# Access Compliance Report

## Public Rights-of-Way

Intersection ID: 9129	Main Street: N_GRAHAM_ST	Cross Street: NORRIS_AV	Location: SE
ADA ID: 329E0776D486	Ramp Type: Combination1	Initial Pass/Fail: Fail	Overall Compliance: No
Codes/Mitigation Info/Possible Solution		Field Measurements/Component Compliance	
Severity Score: 22.5

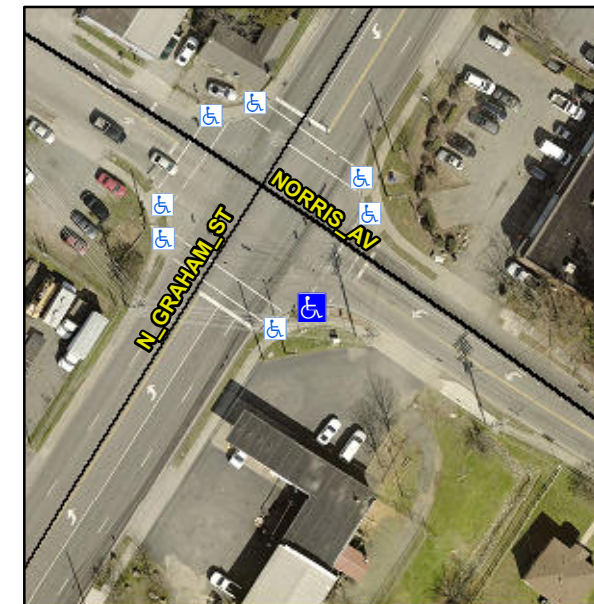
**LT RP < 5%**

**Not Found, R304.5.1, R304.5.3, R304.3.2**

**Remove & Replace Entire Ramp.**
